Caroline Thomas Jacobs, Director
Office of Energy Infrastructure Safety
California Natural Resources Agency
Sacramento, CA 95814
ElectricalUndergroundingPlans@energysafety.ca.gov

Subject: Public Advocates Office's Comments on the Draft Guidelines for the 10-Year Electrical Undergrounding Plan (EUP)

Docket: 2023-UPs

Figure 1 - Project Acceptance Framework

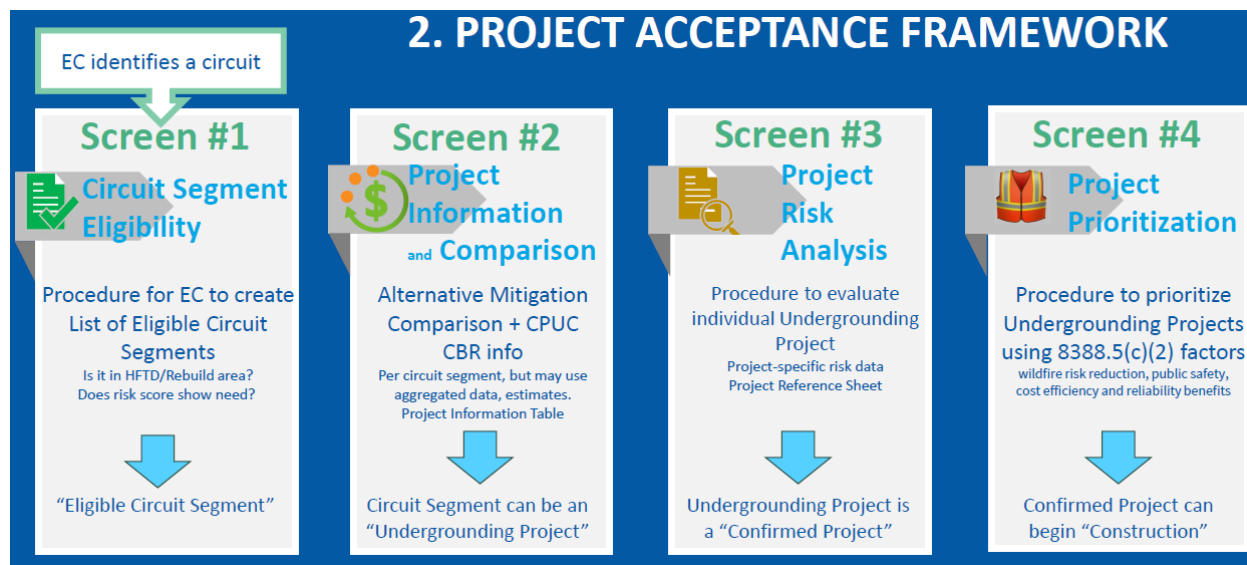
However, the Draft Guidelines improperly substitute “eligible circuit segments” for actual projects. For example, Screen 2 of the Project Acceptance Framework (see Figure 1 below), requires project information and alternative mitigation comparison for *eligible circuit segments* within High Fire Threat Districts (HFTDs) or Fire Rebuild Areas (Eligible Areas).¹⁰ And it specifically states that such *eligible circuit segments* “can be an Undergrounding Project.” The Draft Guidelines also state that the information provided as part of Screen 2 will “constitute the list of Undergrounding Projects identified in the EUP pursuant to section 8388.5(c)(2).”¹¹

A list of *circuit segments*, some of which could be no more than a set of common values, assumptions, and estimates¹² is not the same as a list of confirmed projects that “will be constructed”¹³ as contemplated in the law. And a list of circuit segments is not consistent with CPUC Resolution SPD-15, which correctly and expressly recognizes the statutory mandate for a project-specific plan.¹⁴

Finally, the Draft Guidelines would exacerbate the potential inconsistencies with SPD-15 by instructing that a utility need only provide 25 projects for the project

risk analysis described in Screen 3 above,¹⁵ thereby leaving the majority of eligible undergrounding projects unanalyzed. As a result, Energy Safety may not have reviewed most of the projects received by the Commission for their contribution to risk reduction or reliability improvements under their risk assessment methodology. This also fails to meet the requirements of SB 884.¹⁶

To remedy both issues, the Draft Guidelines should be modified to require a utility to provide all the information that the Guidelines identify as required to complete Screen 3 for all projects identified in Screen 2. Only by assessing the efficacy of a *complete* portfolio of projects can Energy Safety determine whether the Plan and its constituent set of complete projects adequately meet the requirements of the statute.¹⁷ In addition, requiring Screen 3 information for all projects will ensure that Energy Safety has a fully fleshed out baseline assessment of the complete project portfolio against which future compliance assessments can be made.
